MAHNCKE PARK NEIGHBORHOOD CONSERVATION DISTRICT (NCD) 6

Zoning Commission Public Hearing NCD Update

March 19, 2019

Lot Size/Coverage

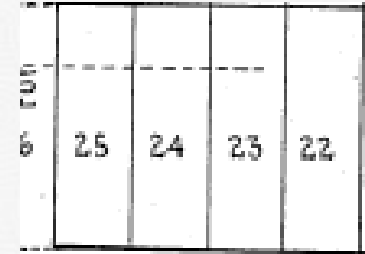
- Taskforce Recommendations:
 - Proposed changes decrease the minimum 50 foot width for a replat to 35 feet for properties south of Parland Place and all lots East of New Braunfels.
- Community Input:
 - Exclude streets that are already platted with 50 foot width lots
- Staff recommendations:
 - Staff updated language that requires 50 foot width lots to maintain a 50 foot width lot requirement when replatting.
 - Staff updated language that allows lots currently platted less than 50 feet in width to replat meeting a 35 foot width.

Lot Size/Coverage (Front Setback)

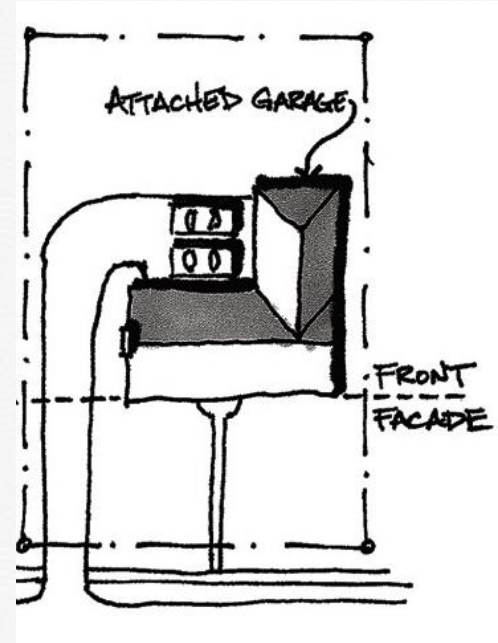
- Taskforce Recommendations:
 - Modifies median front setback from 5 Ft to 8 Ft of median block-face.
 - Proposed revisions that applies the median setback only if a minimum of 5 existing single family residential structures on the block-face.
- Community Input:
 - Define the median setback by blockface, if volunteers can take measurements in time. This becomes the front setback for each blockface.
 - Define primary street.

- Staff recommendations:
 - Staff updated language that keeps the front setback of 5 feet from the median.
 - Staff updated language that removes the applicability of the median setback based on use.
 - Staff updated language that defines primary street as the street in which a property is addressed on.

Garages, Carports, Accessory Structures and Accessory Dwellings

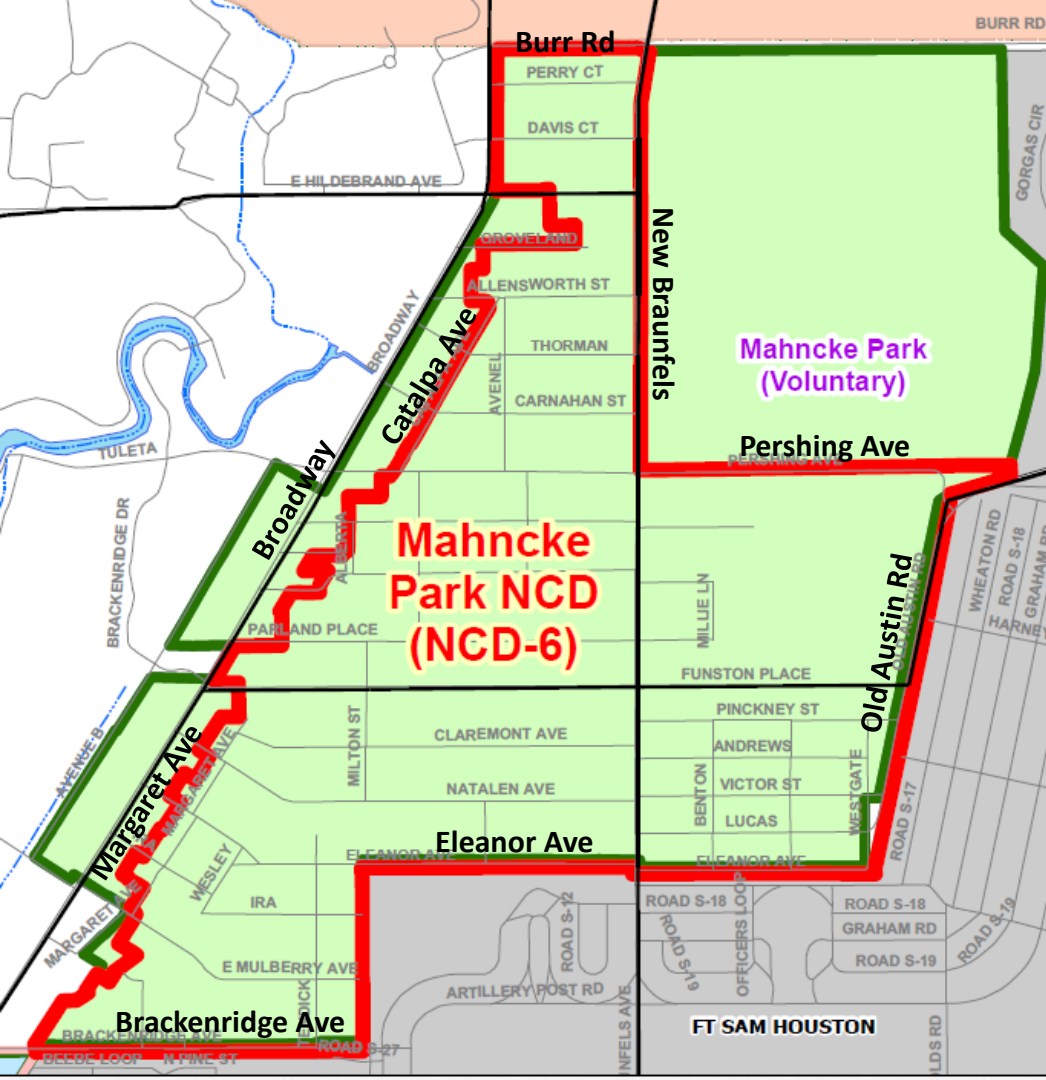
- Taskforce Recommendations:
 - Proposed revisions to placement of garages or carports if facing the same direction as the front façade of the principal dwelling that removes requirement to be detached and behind the principal structure. Proposed language that allows placement behind the principal dwellings forward most architectural feature.
 - Recommended changes to the building materials for vertical supports or structure materials of porte cocheres that now requires a match to the primary structures. No longer allows materials matching primary structure placement and profile.
- Community Input:
 - Allow porte cocheres to be flush with the principal structure's front façade.
 - Clarify language that allows attached garages or carports.

- Staff recommendations:
 - Staff kept language that requires garage or carport to be detached from the principal structure and located behind the principal dwelling if facing the same direction of the front façade. Maintains exemptions for lots less than or equal to 110 feet deep or lots less than 35 feet wide.
 - Staff updated language that clarifies garages or carports not facing the same direction as the front façade may be attached, if located 20 feet behind the front façade.
 - Staff kept language that allows flexibility for use of building materials for vertical supports for replacement or renovations.
